SERVICE BULLETIN

Classification: EL18-017	Reference: NTB18-057	Date: August 7, 2018
-----------------------------	-------------------------	-------------------------

2018 LEAF; MALFUNCTION AND AEB WARNING LIGHTS ON

APPLIED VEHICLES: 2018 LEAF (ZE1)

Figure 2

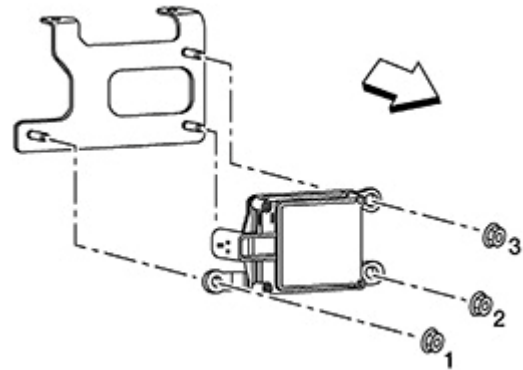
2. Install the new Distance Sensor and torque the nuts in the pattern shown in Figure 2.

- The Distance Sensor is listed in the Parts Information.
- **Do not drop or impact the Distance Sensor.**
- Torque nuts to:
10.0 N·m (1.0 kg-m, **7 ft-lb**).
- Make sure Distance Sensor harness is installed without any twists.

Figure 3

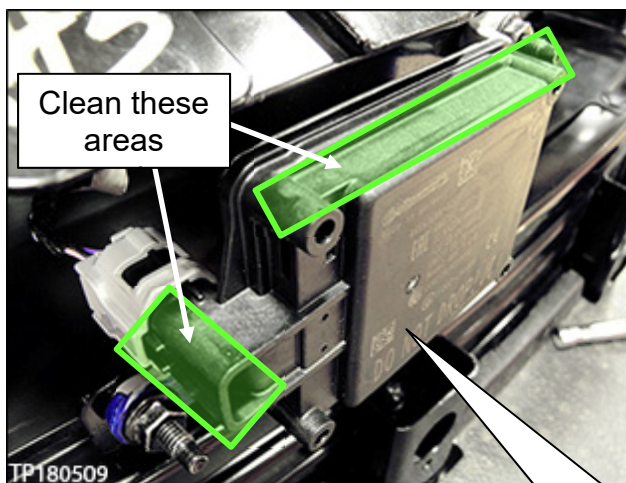
3. Clean the surfaces of the new Distance Sensor, shown in Figure 3.

- Use a soft cloth and isopropyl alcohol.
- Do not allow any isopropyl alcohol into vent (Figure 4).
- **Do not drop or impact the Distance Sensor.**

Figure 5

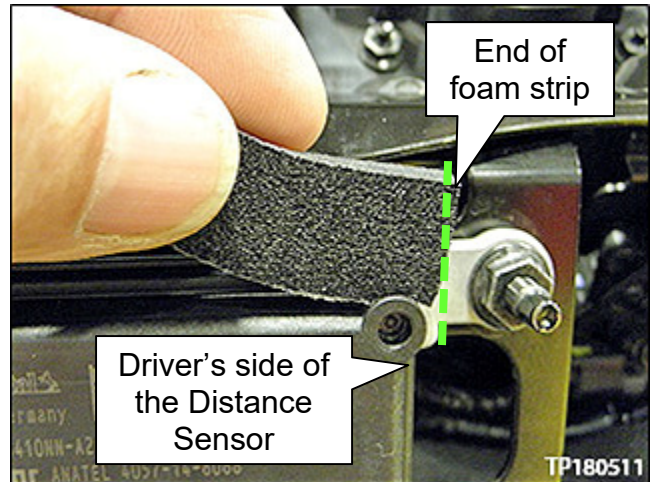
- Foam strip is listed in the Parts Information.
 - a. Remove the self-adhesive protection strip from the foam strip.
 - b. Align one end of the foam strip to the driver's side and raised edge of the Distance Sensor where shown in Figures 5, 6, 7 and 8, and then start to attach.

Figure 6

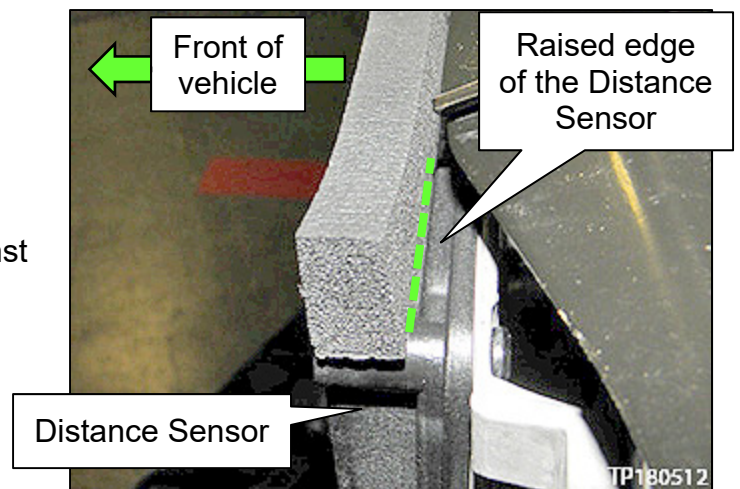
- Figure 6 illustrates alignment of the rear facing edge of foam strip against raised edge of Distance Sensor.

Figure 7

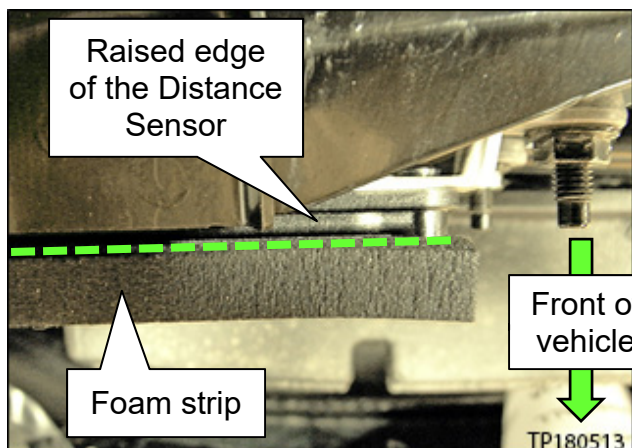
- c. Continue to attach the foam strip along the raised edge of the Distance Sensor.
 - Press firmly to make sure that there is good adhesion between the foam strip and the Distance Sensor.

Figure 9

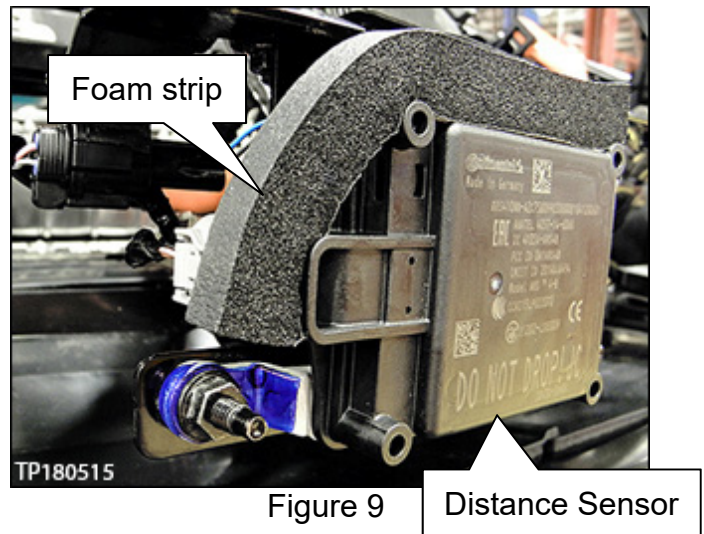
- d. Fold the Foam strip down the left side of the Distance Sensor and attach where shown in Figure 9.

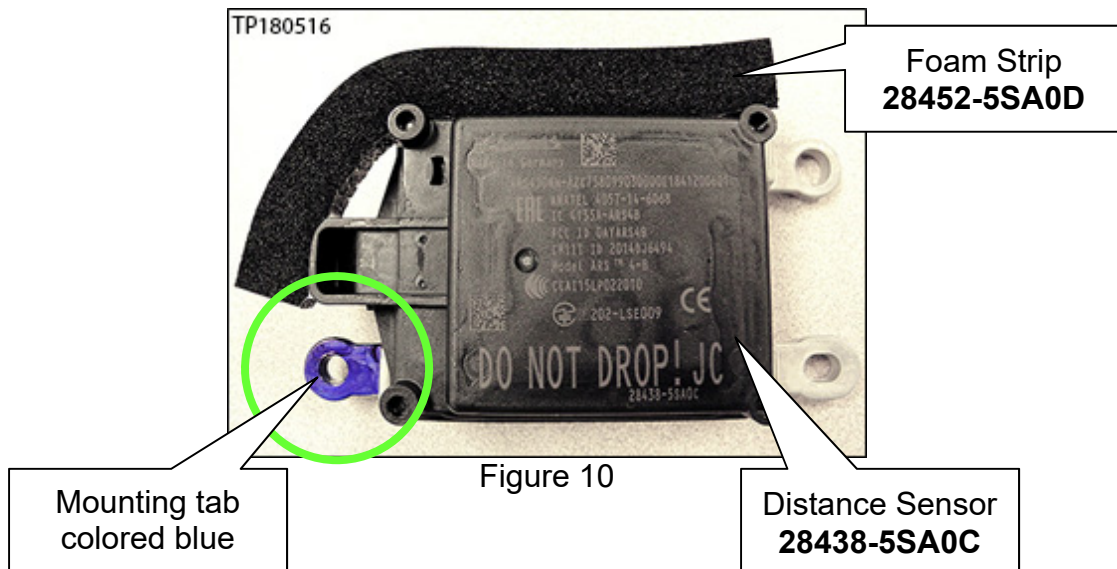
- New Distance sensor will have mounting tab colored blue, as shown in Figure 10.
- Sensor is shown uninstalled and is for reference only.
